STAFF REPORT

APPLICATION: AGENDA ITEMS I.1 and II.1 MAY 30, 2024 MEETING

Re: IWWA Application and CC Recommendation: 769 Hebron Ave

Streambank stabilization

Photo 1: Looking west, lawn and stone eroding into the south bank of the brook. Irrigation tubing in the foreground.

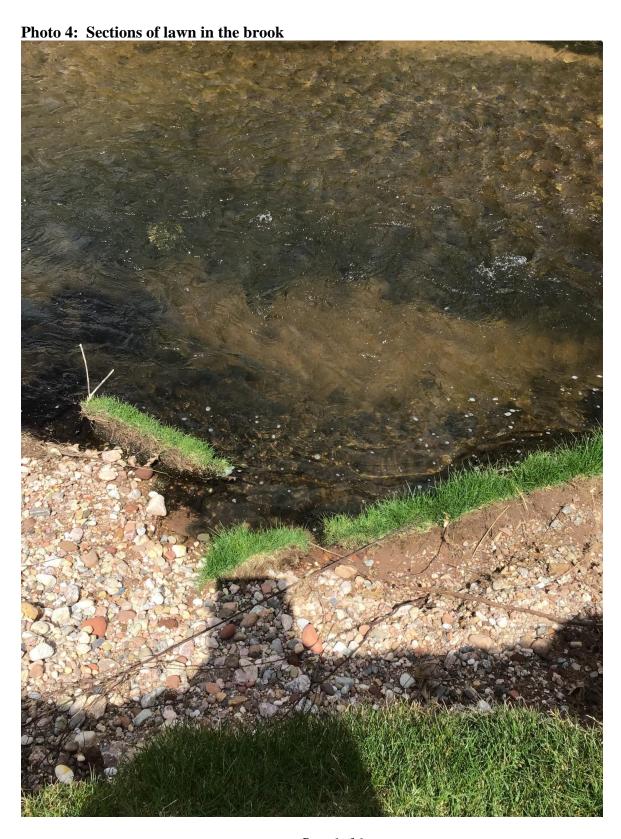
The property is approximately 1.72 acres within the Planned Employment Zone. The property is not encumbered by a conservation easement. The plan locates Salmon Brook on the north side of the property, flowing from east to west. The erosion is affecting the south bank of the brook. The eroded streambank/lawn area has exposed tubing, presumably to siphon water from the brook to water the lawn.
